ADDENDUM 3

PROJECT NAME: Huebner Creek to Medical Center Trail Park Phase 1 (Floyd Curl to Eckert)

DATE: July 24, 2025

PROJECT NO: 23-04004

SHEET NO.: C310

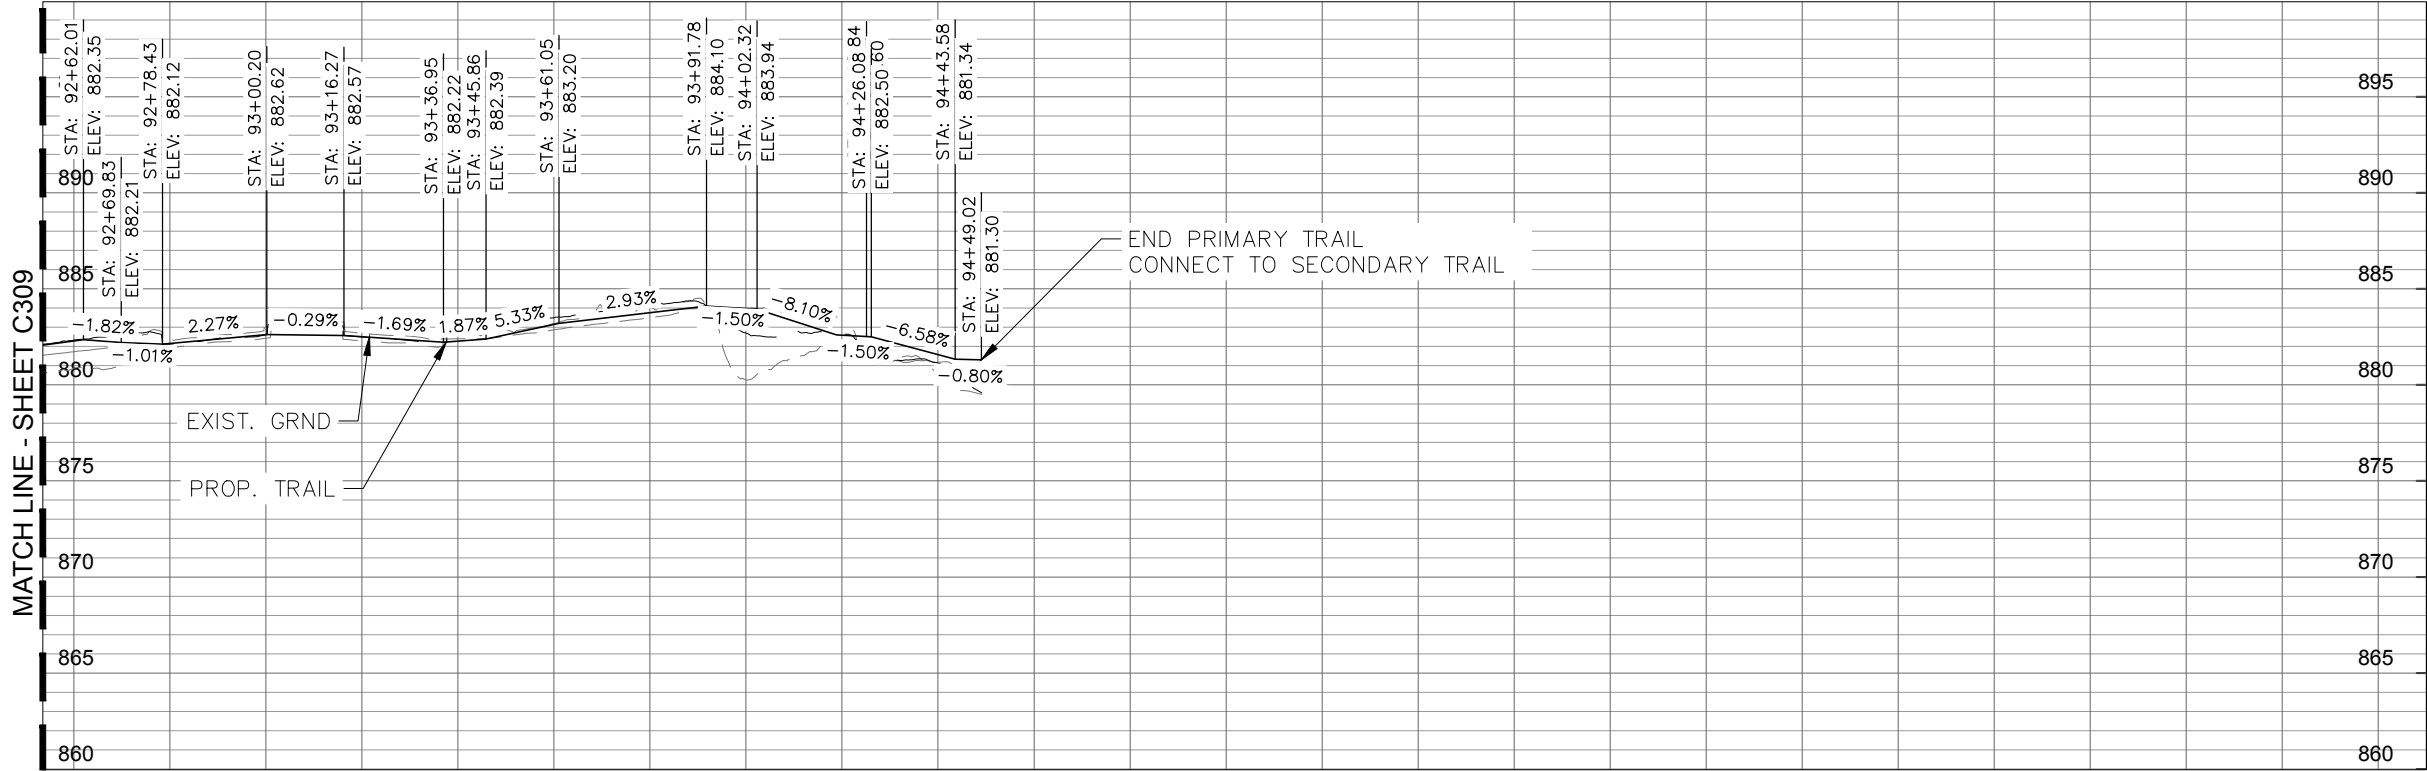
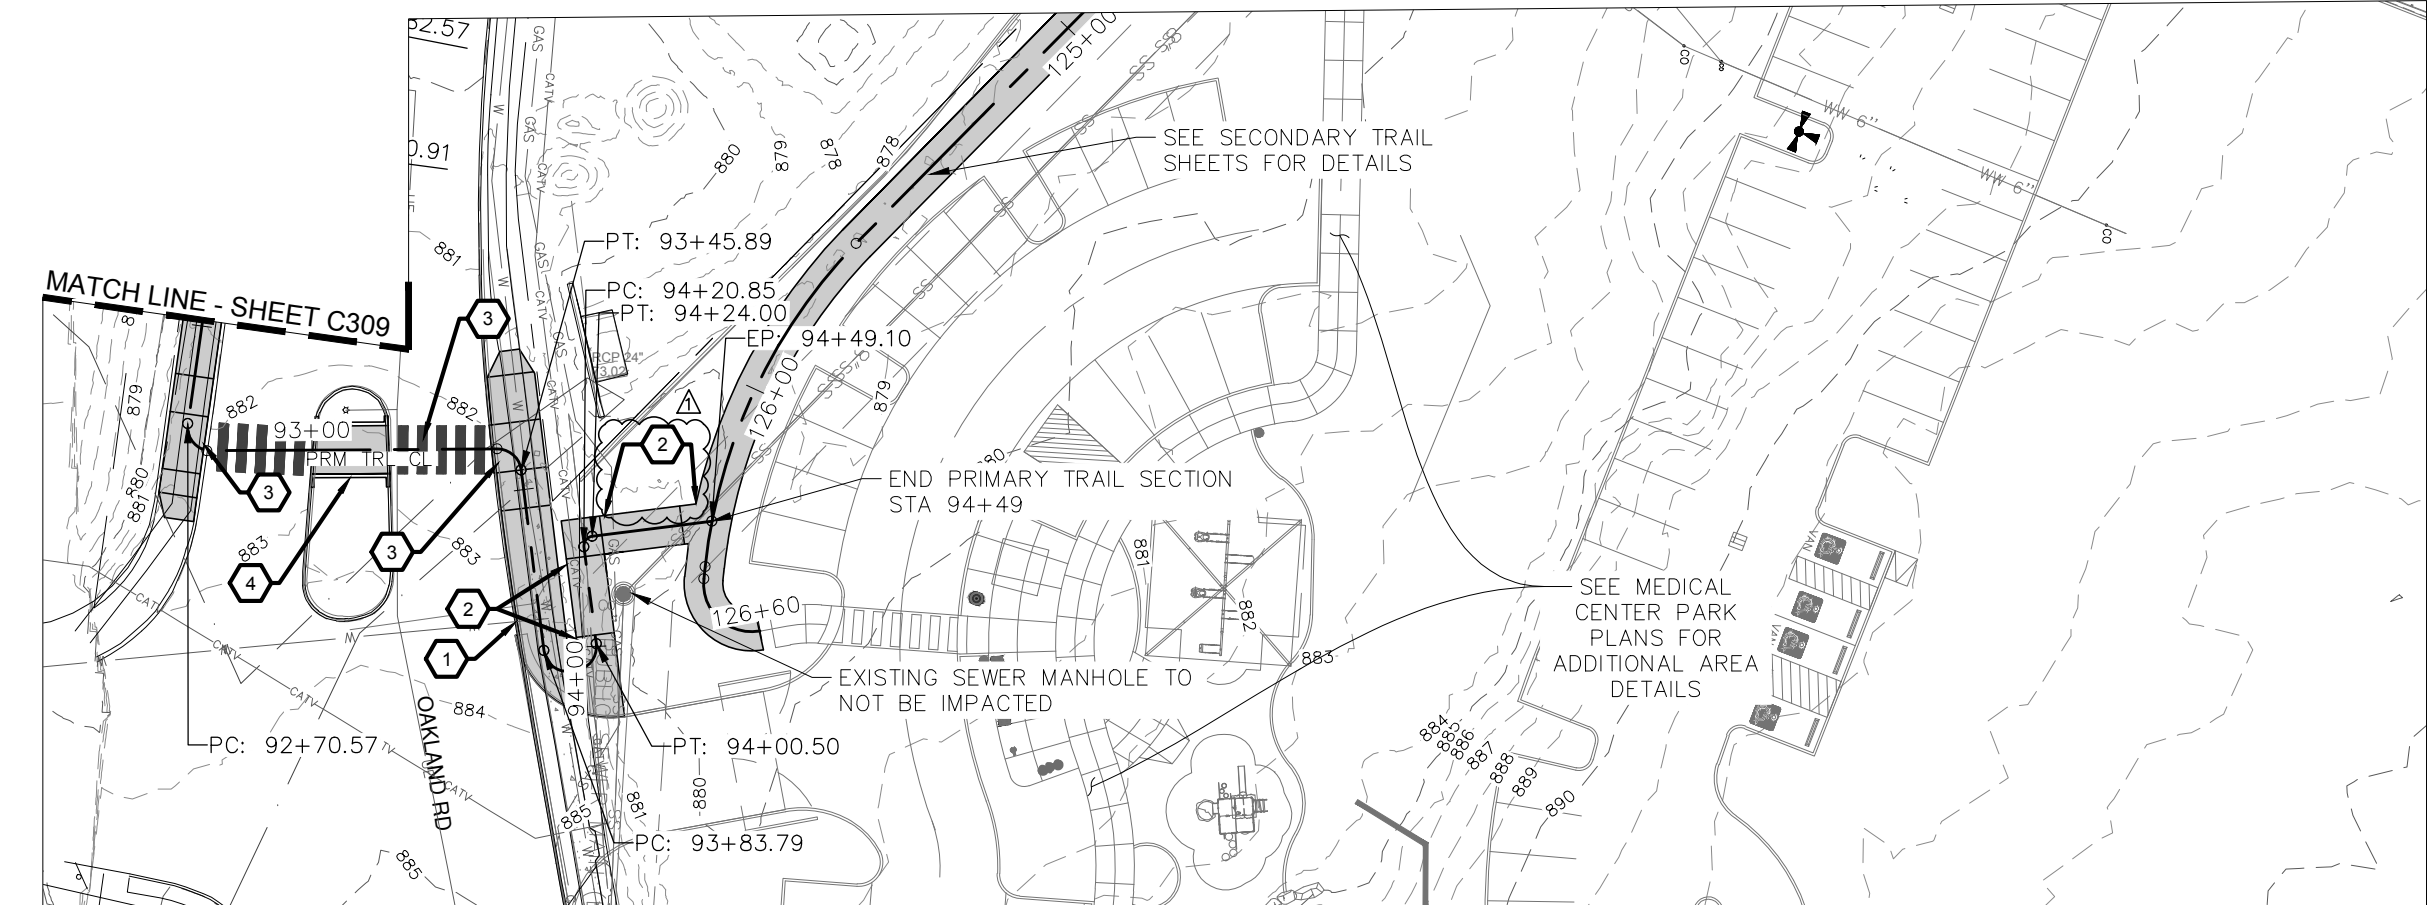
1. **VOLUME 1 – HUEBNER CREEK GREENWAY. SHEET C310 UPDATED PER RAS REVIEWER COMMENTS. HANDRAIL ADDED AT SEGMENT OF RAMP ON BOTH SIDES. FROM STA: 93+45.86 TO STA: 93+91.78.**

HANDRAIL SHALL BE REQUIRED TO MEET ALL FEDERAL, STATE, AND LOCAL CODES. DETAIL TO BE SIMILAR TO 2/L3323 WITH HANDRAIL MOUNTED 34”-38” TO GUARDRAIL AND MEETING REQUIREMENTS LISTED IN 2012 TEXAS ACCESSIBILITY STANDARDS, SECTION 505.

MATERIAL FOR HANDRAIL SHALL BE GRADE 316 STAINLESS STEEL W/ BRUSHED FINISH.
